3000 Series Zeus Pods Product Improvements

NOTICE		
Revised July 2012. This bulletin supersedes the previous bulletin number 2012-65 June 2012.		
Model	Product Improvement	Serial Range of Affected Units
Zeus JH Pods	Hydraulic Hose Inspection/Replacement	0M963373–0M966652
Zeus JH Pods	Hydraulic Pressure Transducer Replacement	0M963945–0M967171
*Zeus JH Pods	Electronic Module Reflash	0M963373–0M968241

51266

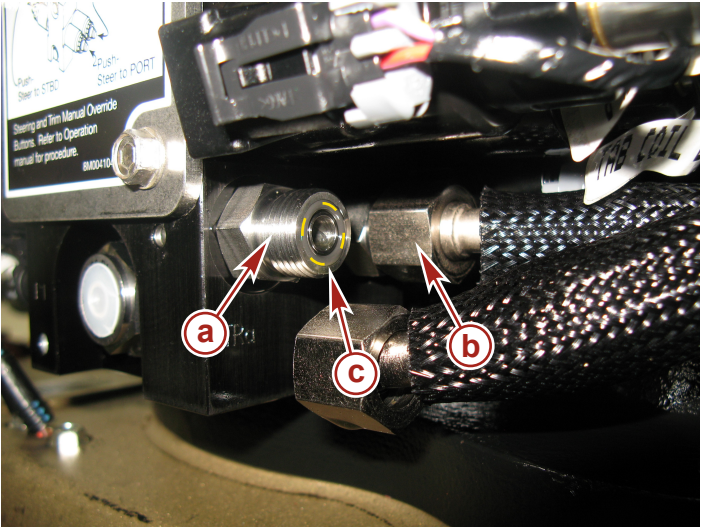
Use the following chart for the part numbers of each hose. Replace all four high-pressure steering and trim tab hoses if any pod is found to have leaking hoses, along with the hoses on all pods on the vessel.

- a** - 8M0053639 from steering manifold port A to upper port on trim manifold
- b** - 8M0053640 from steering manifold port B to lower port on trim manifold
- c** - 8M0053638 hydraulic pump to high pressure filter
- d** - 8M0053637 high pressure filter to steering manifold

51264

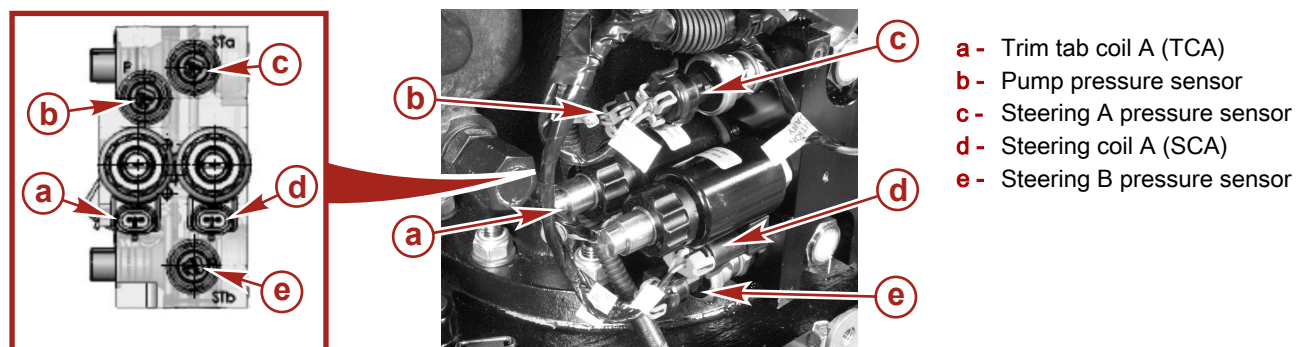
- a** - Port A on steering manifold
- b** - Port B on steering manifold
- c** - Verify o-ring remains intact in fitting before installation of new hose

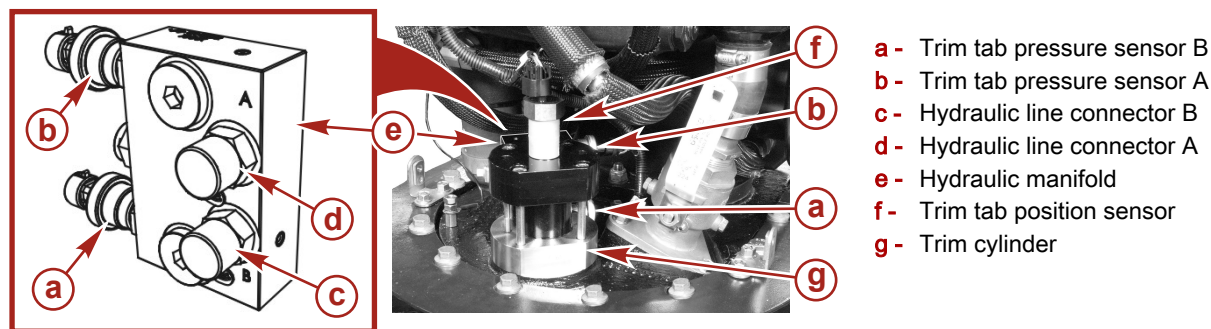
Each pod's hydraulic trim tab manifold contains two (2) pressure transducers. These trim tab pressure transducers are identified by the letters a and b in the following illustration.

If the inspection reveals that the pressure transducers have already been changed to the new sensor shown in Figure B above, it is not necessary to replace them. If the inspection reveals the pressure transducers for the steering and trim tab systems have not been replaced and are identified as the transducer shown in Figure A above, replace each of the transducers on each pod. JH Zeus applications will need five total transducers for steering and trim tab hydraulic systems.
